From: [REDACTED]
To: [MCP-Chair](#)
Subject: University Boulevard
Date: Wednesday, February 19, 2025 7:32:00 PM

I write with regard to the University Boulevard Corridor Plan, which will affect my daily commute dramatically. For the last 18 years, I have commuted daily from my home in Kemp Mill to my law firm in downtown Washington, DC. Unfortunately, my commute has always been difficult, and regularly has taken more time than it ought to have. In fact, it has taken me more longer to get to and from my workplace—whether by subway or car—than it did to get to downtown Baltimore, where I used to work. For years, I took the subway, but service was, regrettably, poor. Often I encountered “single tracking” and even faced several months in which there was no red-line service. During COVID, conditions on the Metro deteriorated and I concluded that it was no longer safe to travel via subway.

Figure 14 - AM Peak Hour Vehicles per Lane - Year 2045 Proposed Plan Recommendations

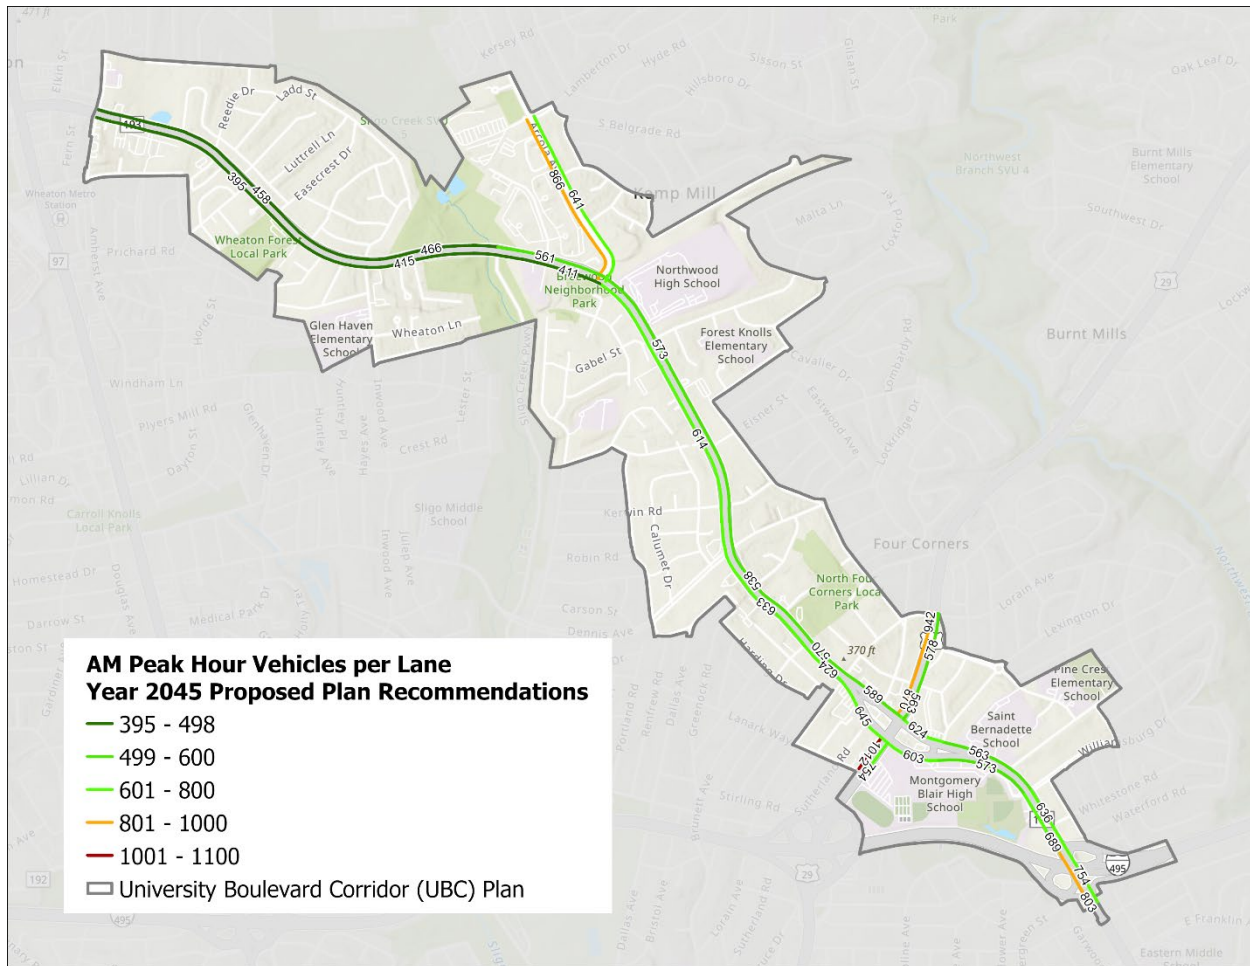
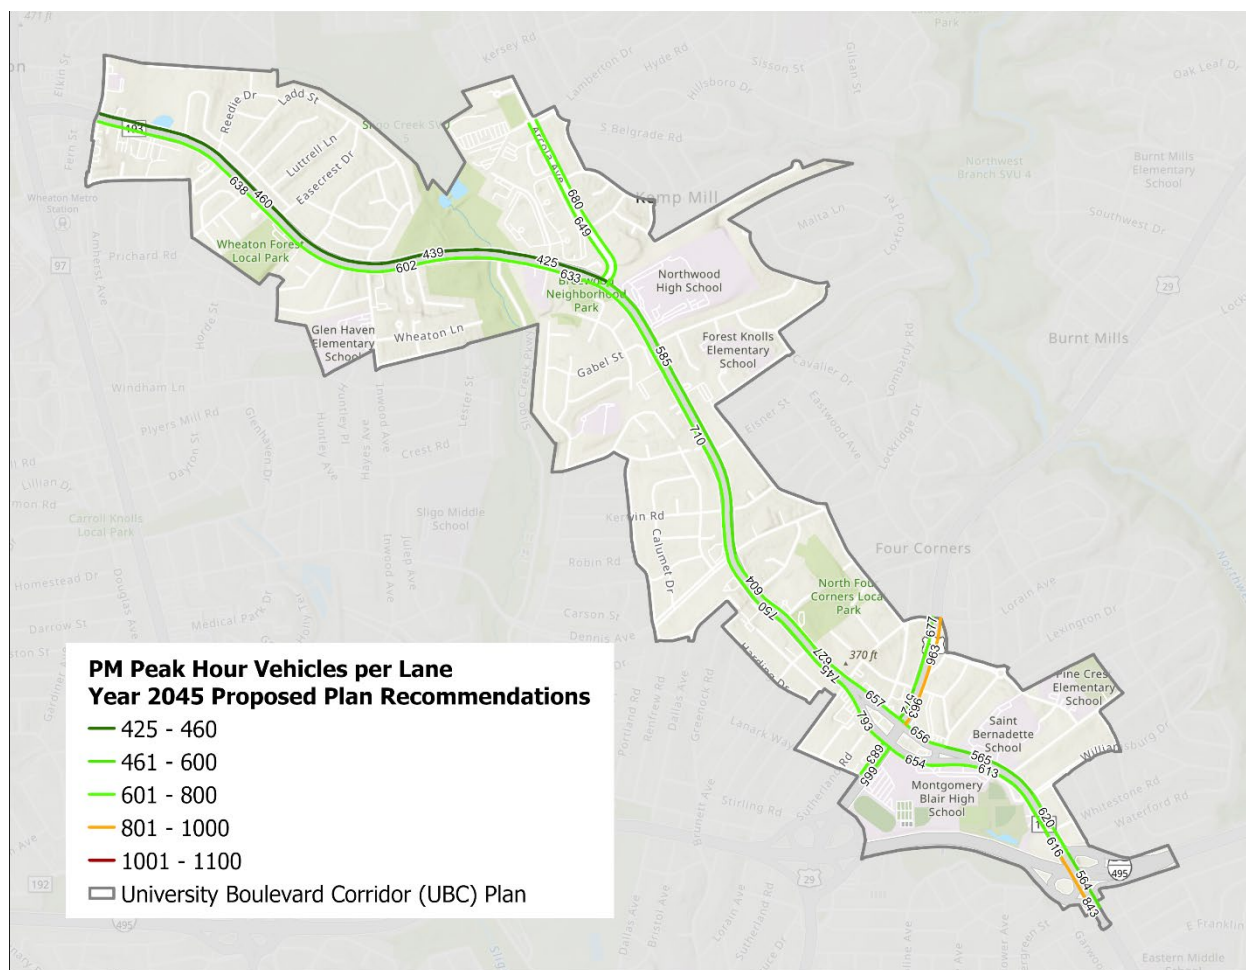
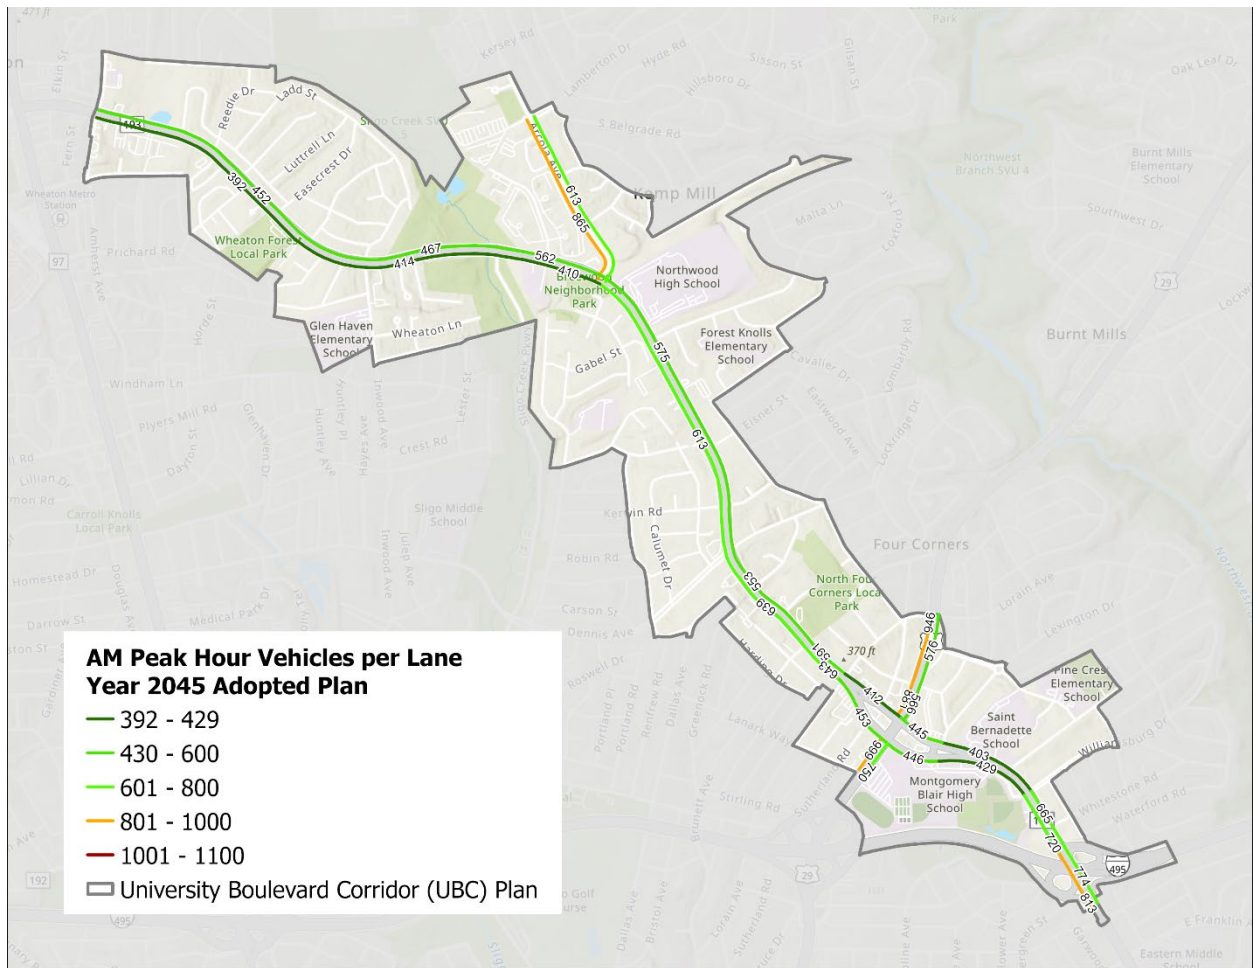
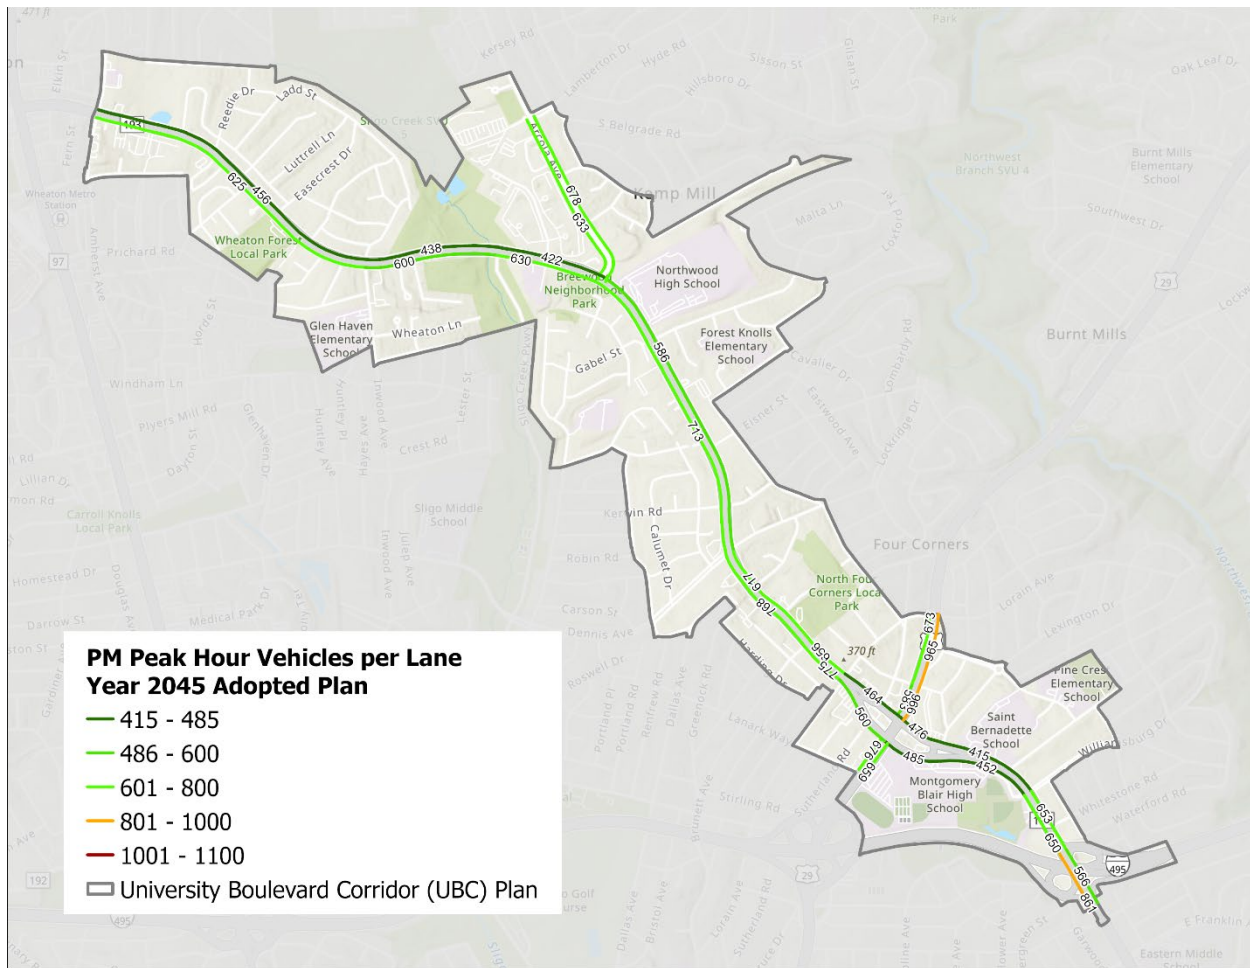
In the UBCP's own analysis – *Appendix F: Transportation section* – it shows a *significant* increase of traffic flowing into and out of neighborhood streets with the Street Grid in place. **Tables 3 & 4** shows the closer to the Four Corners intersection, the greater increase of traffic with the closest streets of Lorain & Lanark seeing **a doubling or more of traffic flowing into/out of our neighborhood**, and that is *after* all of the 2045 assumptions of reduced vehicular travel. At peak times, the traffic tables and modeling maps (**Figures 14 - 17**) show more peak vehicles per hour per lane cutting through South Four Corners than it does on some stretches of University Blvd. The neighborhood traffic analysis concludes on page 23 stating (emphasis added):
